Village of Eden Oaks
Oak Harbor Blvd.
St. Tammany Parish - Slidell, LA.
Sheet Title: Landscape Plan

PARCEL 14-1
OAK HARBOR COMMERCIAL, PHASE 1
SECTION 34, T9S-R14E
ST. TAMMANY PARISH, LOUISIANA

This is in response to the comments received on August 14, 2025, regarding a commercial development at Parcel 14-1 in Oak Harbor Subdivision. The comments were addressed by the following:

SECTION A-A

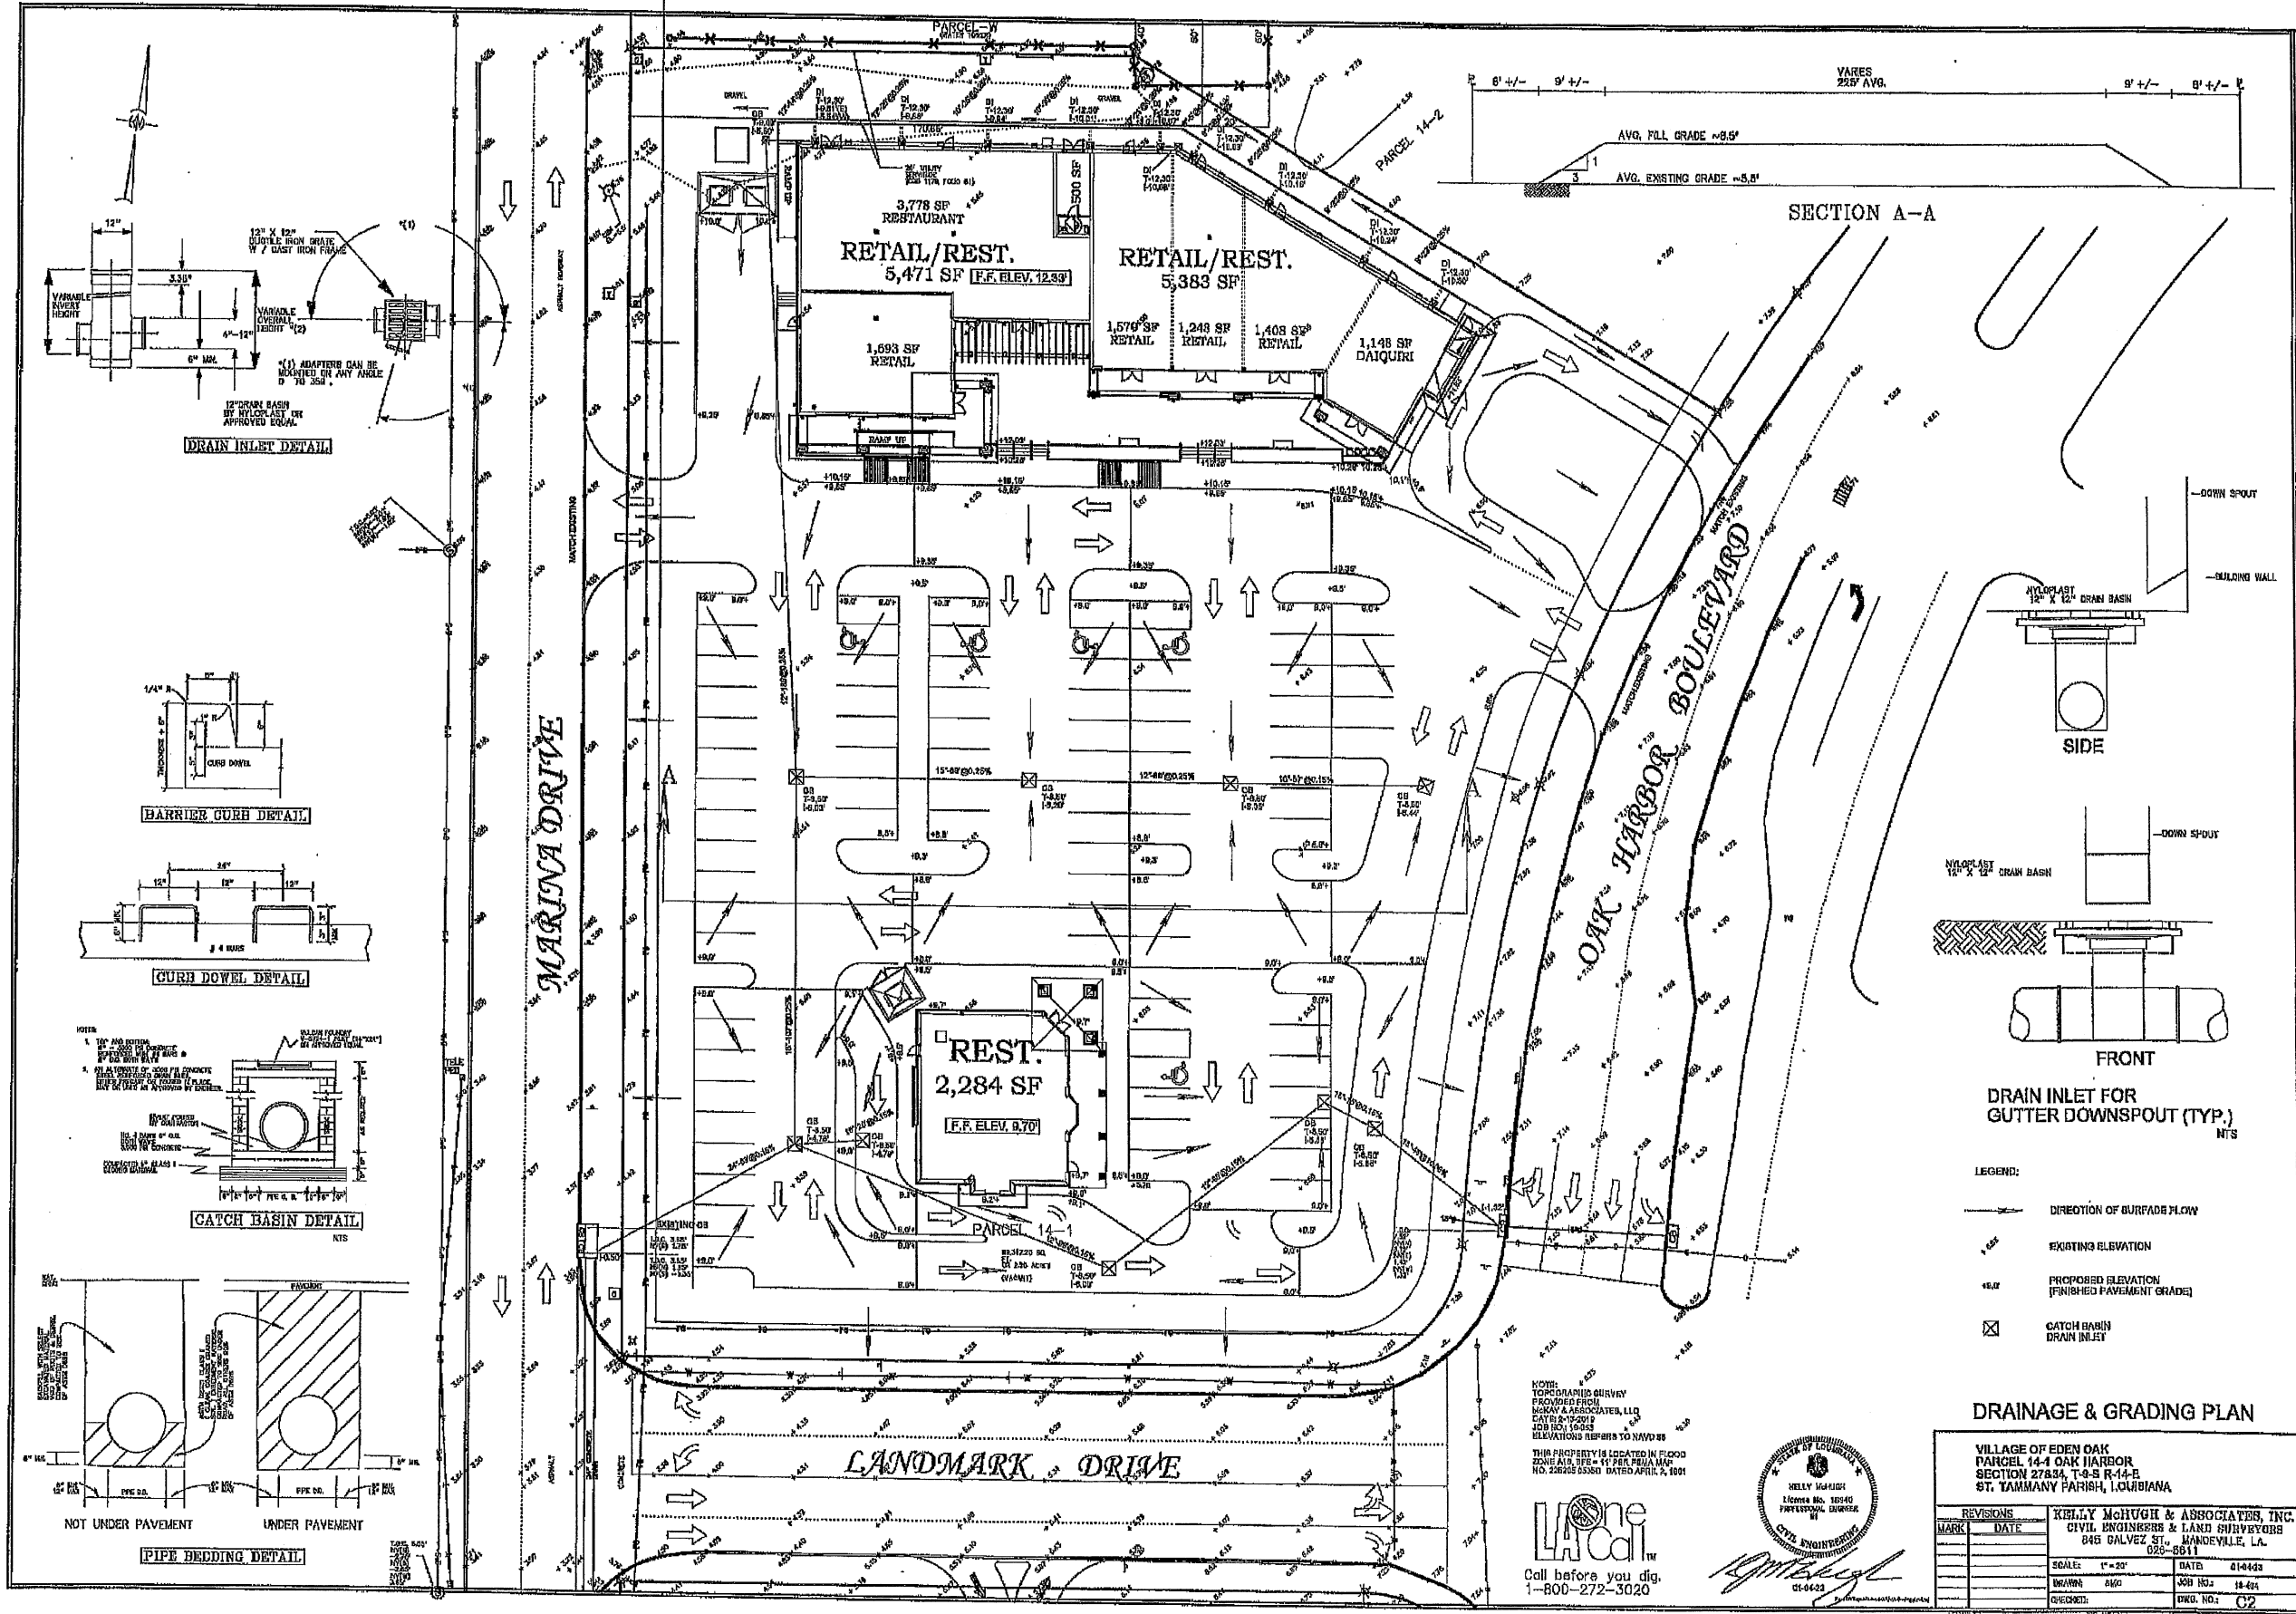
3. Cross-section - Provide cross-section including proposed elevations and dimensions from building to property line.
 - a. Refer to Exhibit No. 2 (two sheets). Sheet 1, plan view, includes location of section and the dimensions. Sheet 2 contains the section view labeled (A-A).

4. Cross-section – The proposed F.F.E. is ~8.5' above natural grade at this location. Show how fill will be contained. If a retaining wall is required, provide proposed construction details.

6. Cross-section – Provide cross-section for the driveway transition from the parish road to the finish parking lot.

7. Cross-section – Provide cross-section including proposed elevations and dimensions from edge of pavement to property line.
 - a. Refer to Exhibit No. 2 (two sheets). Sheet 1, plan view, includes location of section and the dimensions. Sheet 2 contains the section view labeled (C-C).

- a. Refer to Exhibit No. 2 (two sheets). Sheet 2 contains the section view labeled (A-A).
5. Cross-section – Provide cross-section including proposed elevations and dimensions from the edge of pavement to property line.

- a. Refer to Exhibit No. 2 (two sheets). Sheet 1, plan view, includes location of section and the dimensions. Sheet 2 contains the section view labeled (E-E).

- a. Refer to Exhibit No. 2 (two sheets). Sheet 1, plan view, includes location of section and the dimensions. Sheet 2 contains the section view labeled (B-B).
